WARNER'S POND RESTORATION PROJECT

PROJECT #2243

ADDENDUM #1

Re: **Contract No. 2243 – Warner's Pond Restoration Project
Addendum #1**

3.11 WINTERIZATION

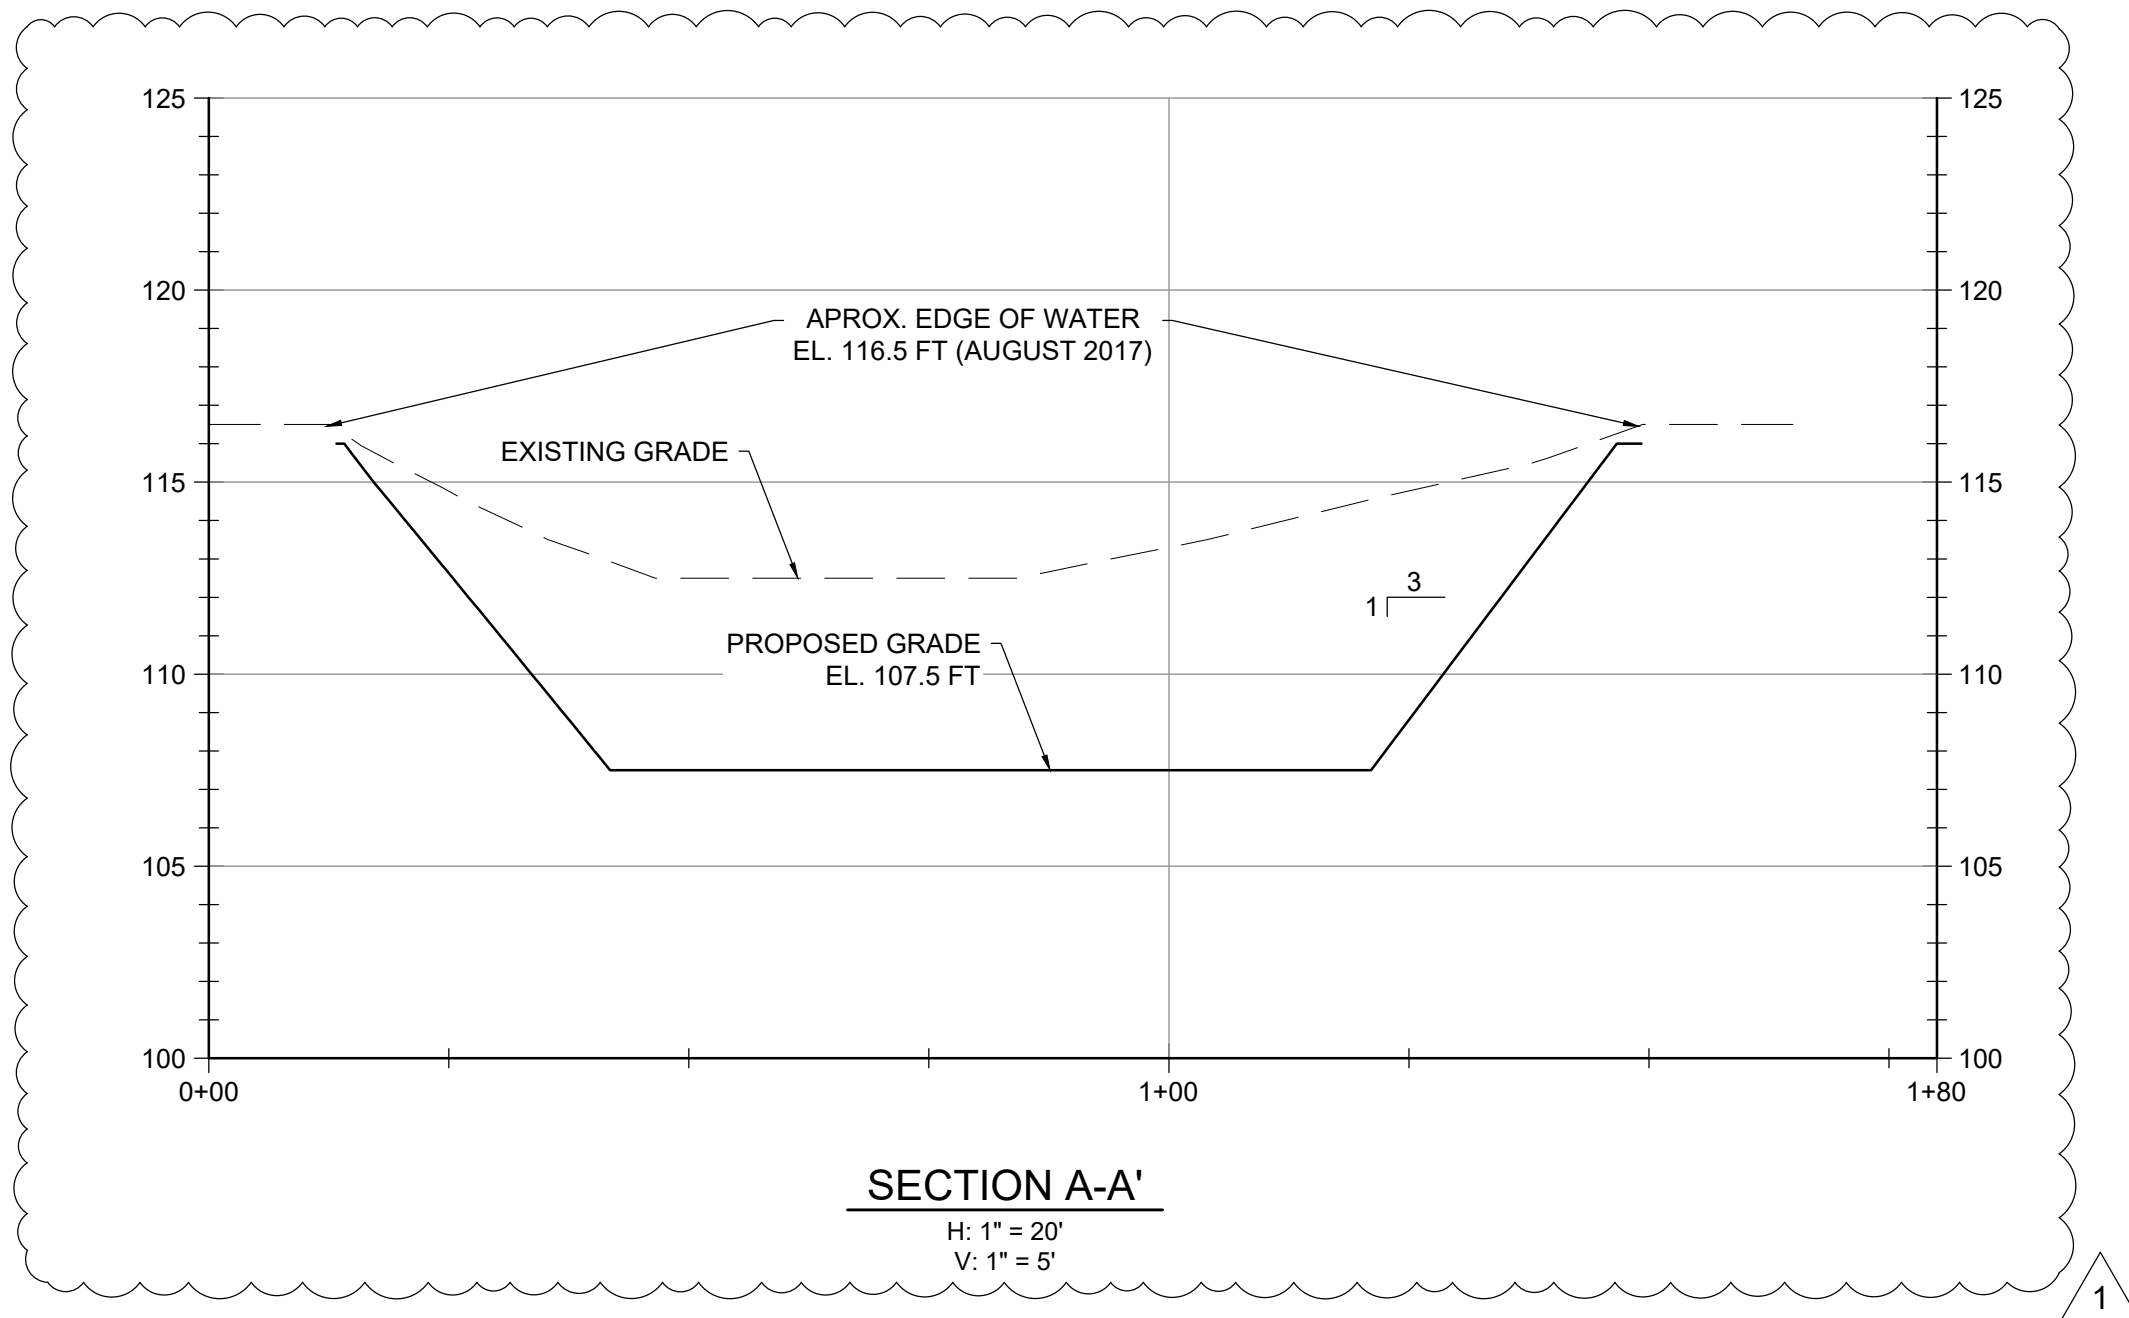
- a. Based on drawing Section D-D it looks like the core log is to be installed underwater. Is this correct?

20. Question: Please reference Drawing C-104 and C-301 showing Coir Logs to be installed at the perimeter of the Wetland Shelf. Please confirm that the Town desires these to be placed under water.

33. Question: Is the 1' of over dredge paid for?

Response: Yes. Please see updated coir log detail on Sheet C-301.

Response: The wetland shelf must be constructed within the footprint indicated in the project plans and the surface area of the wetland shelf surface must be substantially as indicated on the project plans. Therefore, the side slopes of the wetland shelf will be required to be substantially as indicated on the project plans. Refer to the updated Section D-D' detail on Sheet C-301.

Response: There is no over dredge allowance for the project. Sheet C-301 has been revised to remove over dredge surface. The Dredging section has been revised to remove references to over dredge allowance.

DEWATERING AREA PERIMETER CONTROL
NOT TO SCALE

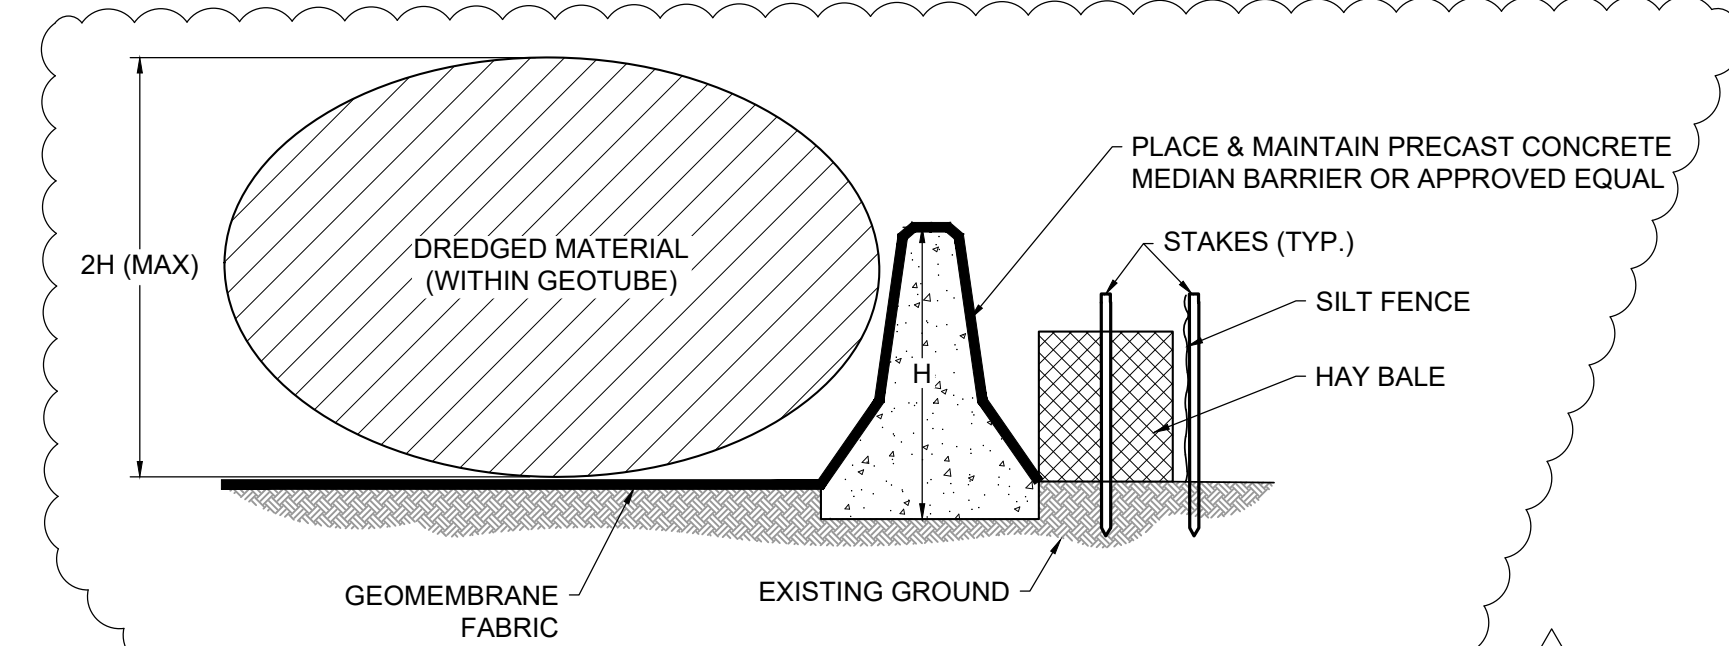
6. Question: Is it anticipated that the dewatering pad will need to be developed to produce a flat area with a .5% slope to the sediment basin? The pad will also need a minimal liner for the pad and the basin. Preliminary evaluation will require the top 6' of topsoil to be removed and a 3' cut and fill to meet the minimum standard for the use of geotextile bags.

Response: Contractor shall regrade dewatering area to create slopes that will prevent geotubes from rolling or install precast concrete median barriers that are at least 1/2 of the geotube manufacturers recommended fill height. See amended notes on Sheet C-501.

1. TO PREVENT THE GEOTUBES FROM ROLLING THE CONTRACTOR SHALL REGRADE DEWATERING AREA OR INSTALL PRECAST CONCRETE MEDIAN BARRIERS ON THE DOWNHILL SIDE OF THE GEOTUBE THAT ARE AT LEAST HALF OF THE GEOTUBE MANUFACTURER'S RECOMMENDED FILL HEIGHT.
2. IF THE CONTRACTOR ELECTS TO REGRADE THE DEWATERING AREA THE REGRADING SHALL BE PERFORMED SO THE MAXIMUM EXCAVATION DEPTH DOES NOT EXCEED 18 INCHES.
3. THE CONTRACTOR IS NOT REQUIRED TO SEGREGATE TOPSOIL EXCAVATED TO REGRADE THE DEWATERING AREA.
